5. PUBLIC HEARING – SPECIAL USE AND PRELIMINARY SITE PLAN REVIEW (SU JPLN2021-001) - Proposed Panera Bread Café (with Drive Through), East side of Coolidge, south of Maple (1484 Coolidge), Section 32, Currently Zoned MR (Maple Road) District

SUBJECT: PUBLIC HEARING – SPECIAL USE AND PRELIMINARY SITE PLAN REVIEW (SU JPLN2021-001) - Proposed Panera Bread Cafe, East side of Coolidge, south of Maple (1484 Coolidge), Section 32, Currently Zoned MR (Maple Road) District

Preliminary Site Plan and Special Use Review For City of Troy, Michigan

Project Name: Panera-Coolidge
Plan Date: August 20, 2021
Location: 1484 Coolidge Highway
Zoning: MR, Maple Road
Action Requested: Site Plan and Special Use Approval

LANDSCAPE PLAN

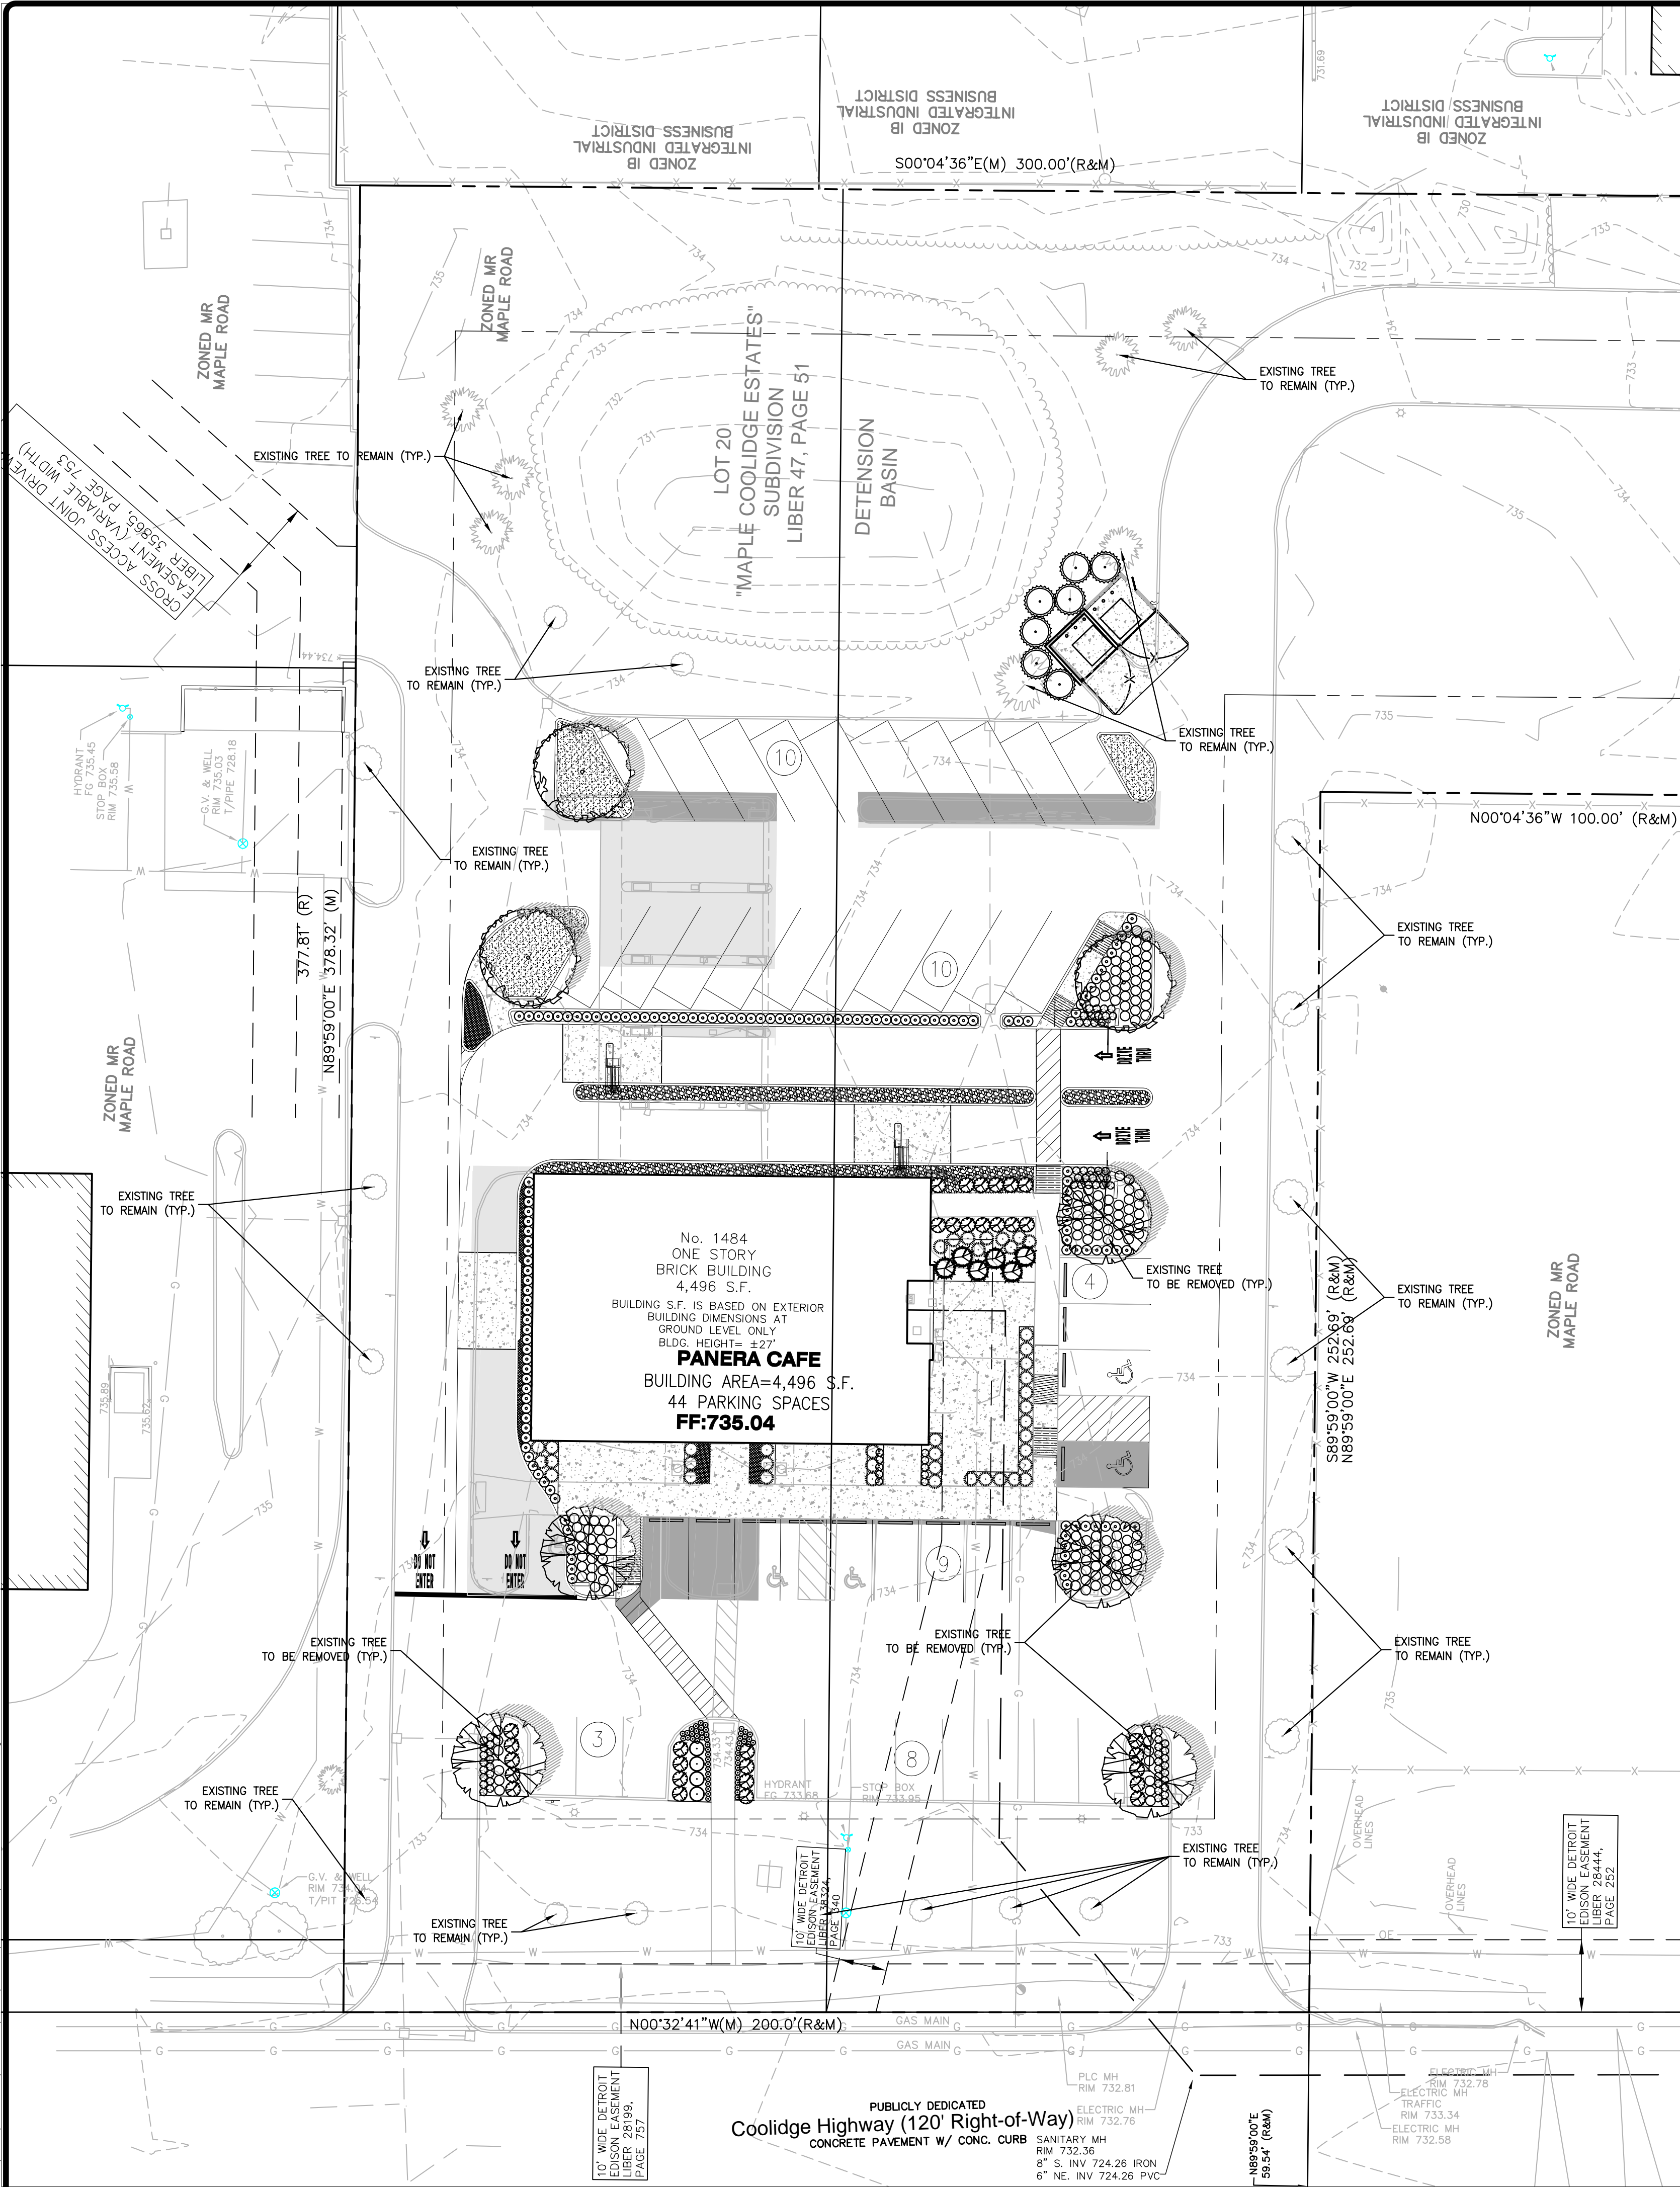
The applicant has not indicated screening of trash enclosure.

Items to be Addressed: Provide trash enclosure screening.

P&Z - EXTERIOR ELEVATIONS

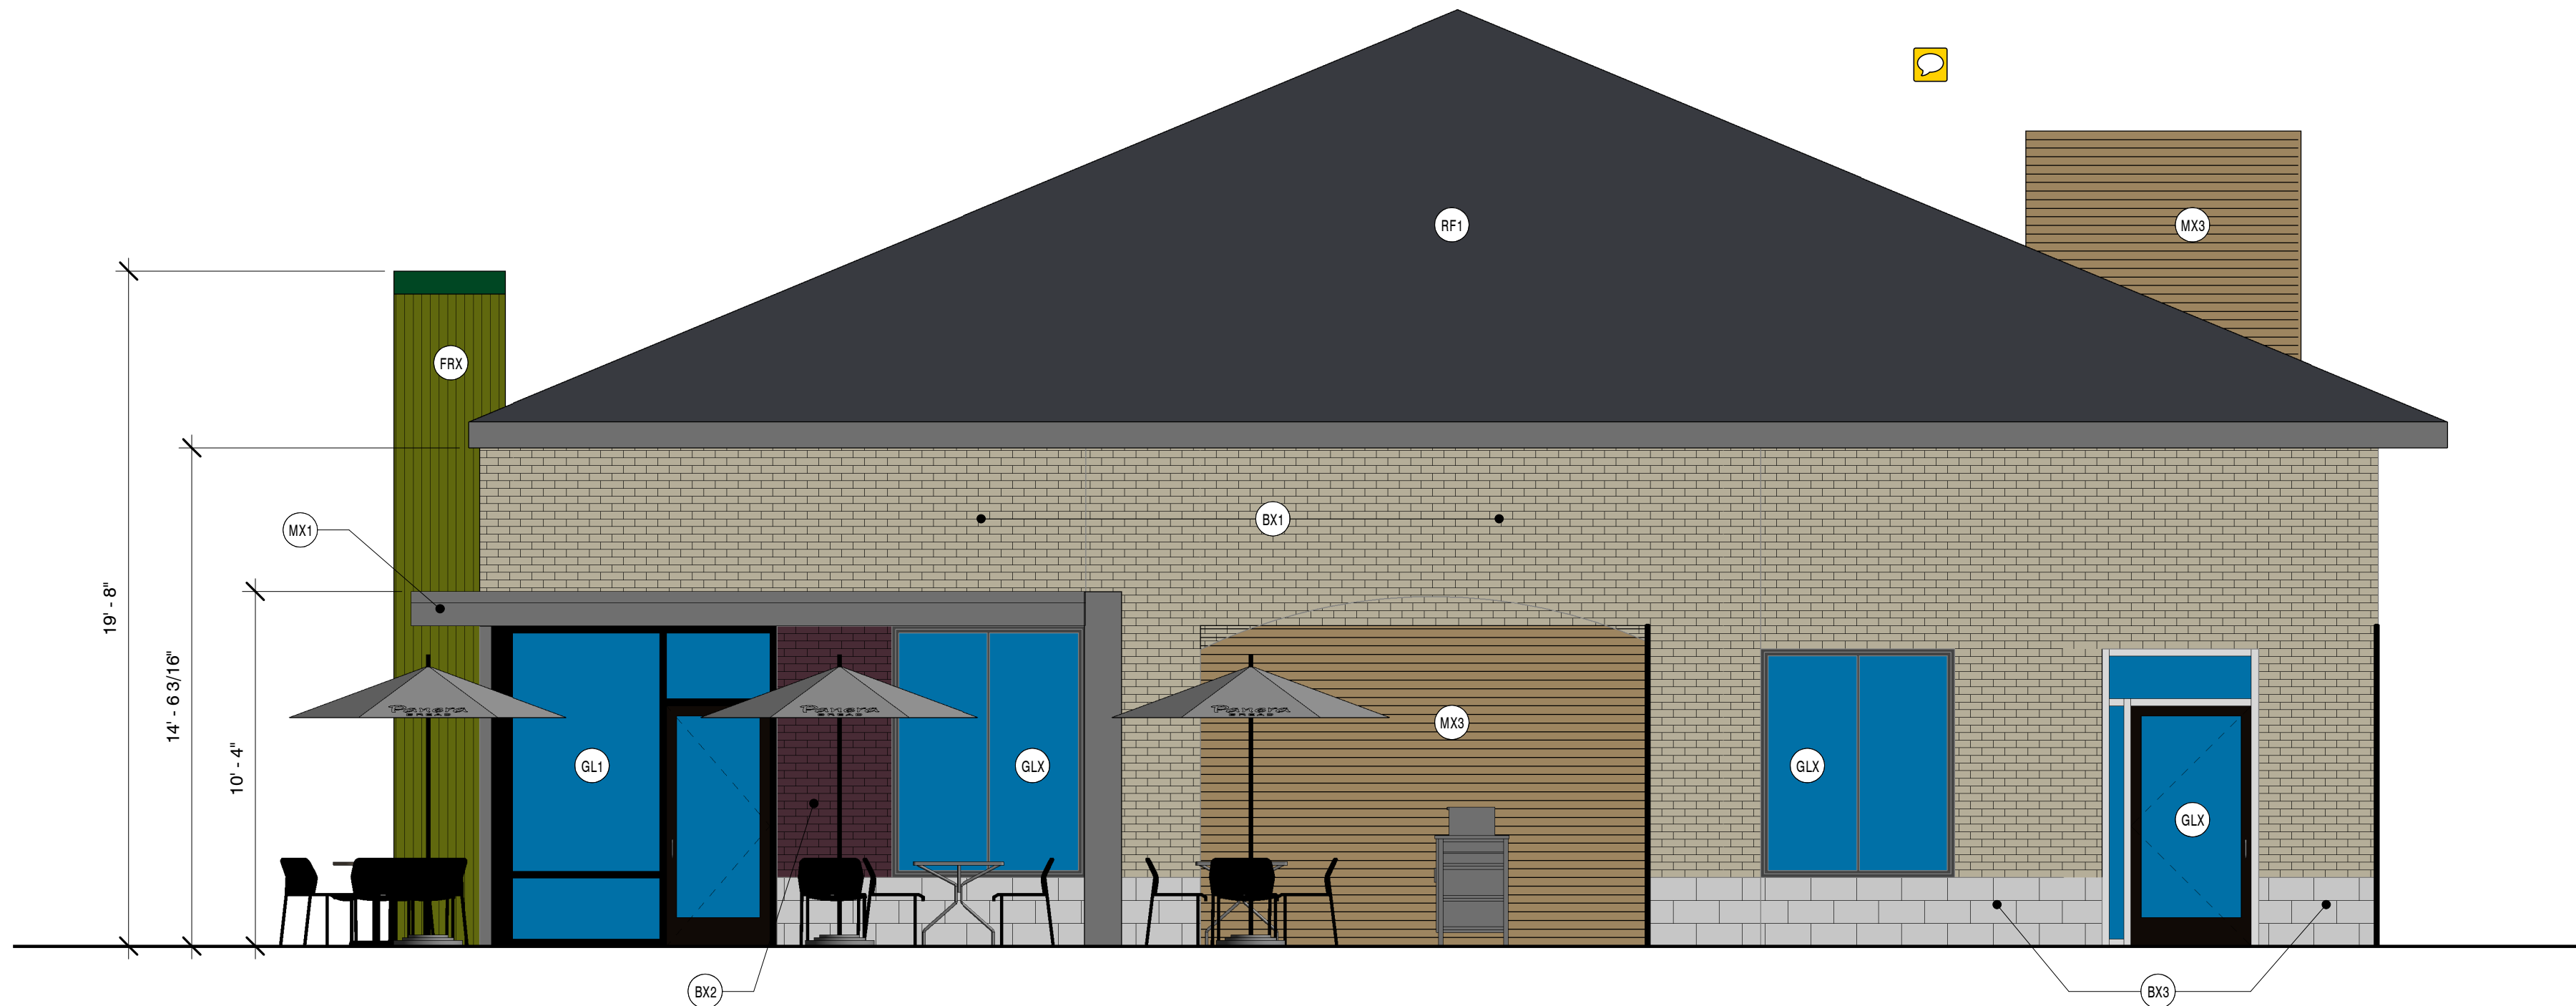
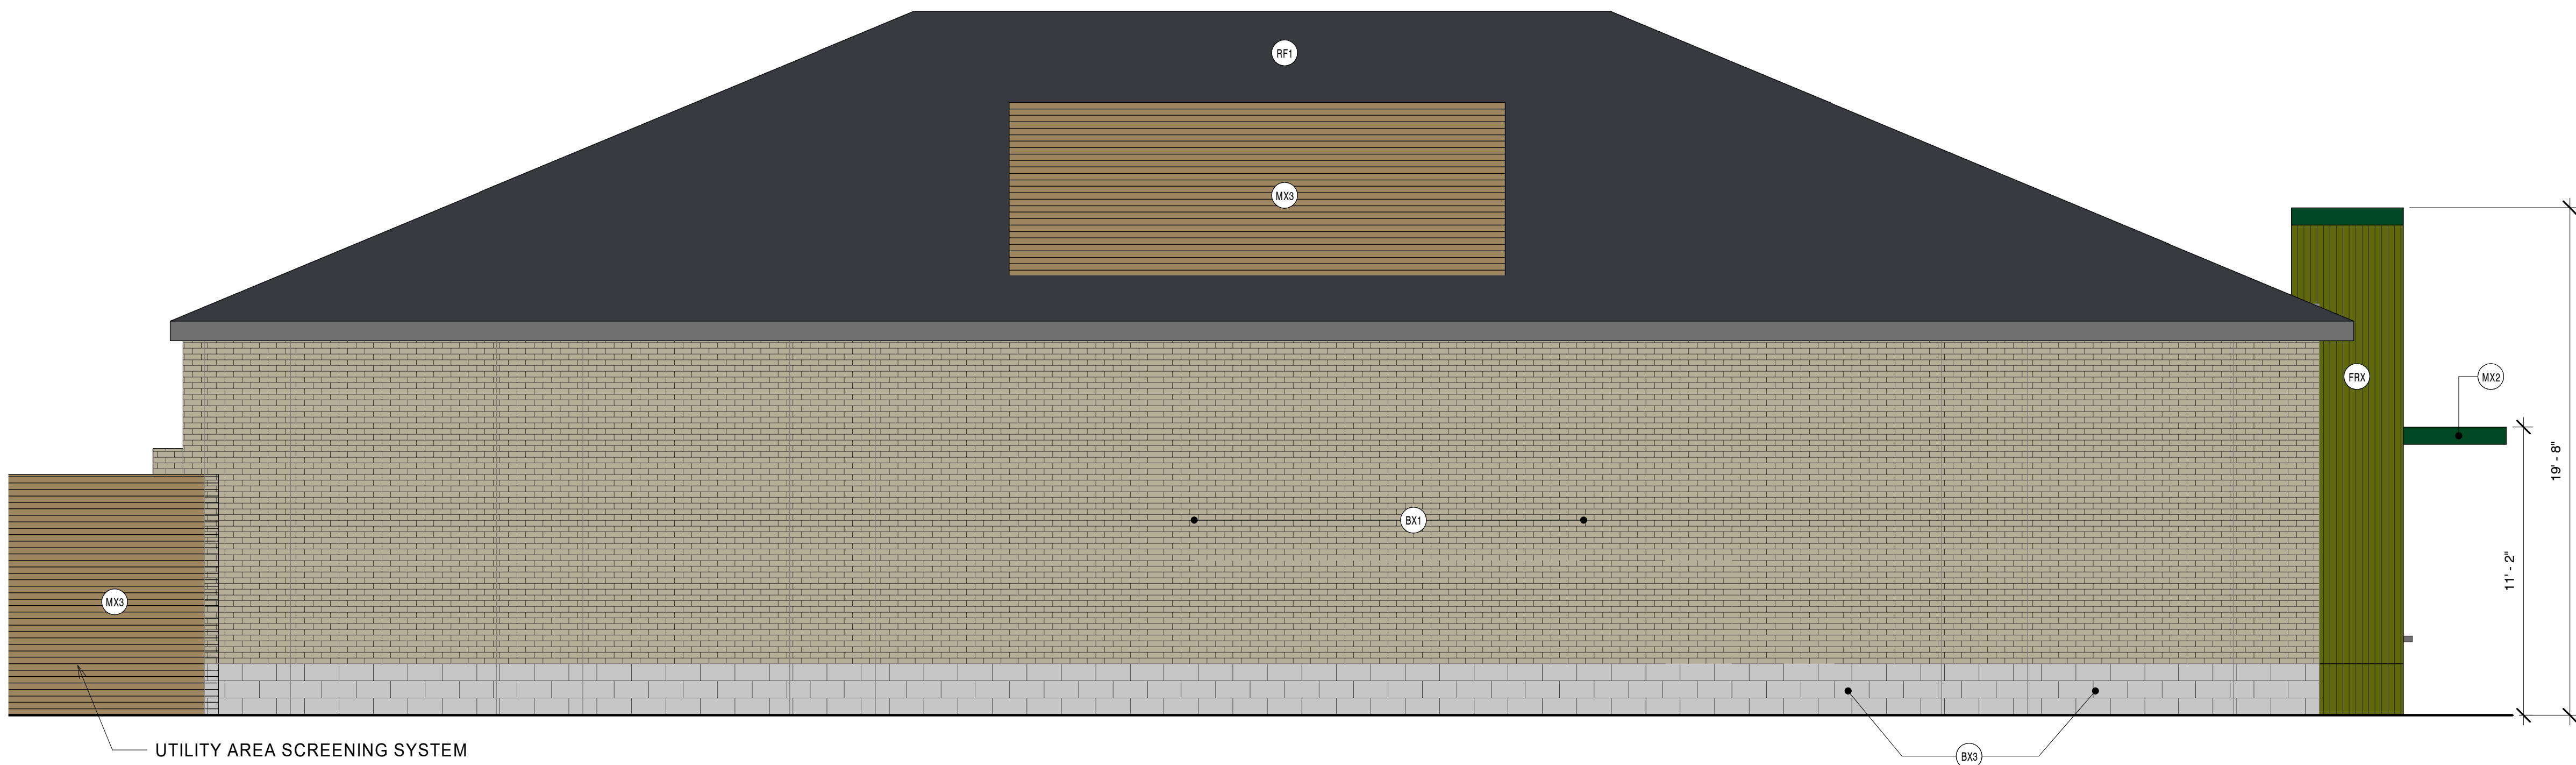
The applicant has submitted elevations and floor plans. The proposed materials include painted brick (existing), glass, CMU, and fiberglass panel. The applicant is required to provide 50% transparency along the west elevation (front), and 30% on south elevation. It appears that the transparency is met but calculations were not provided.

Items to be Addressed: Confirm transparency requirements.
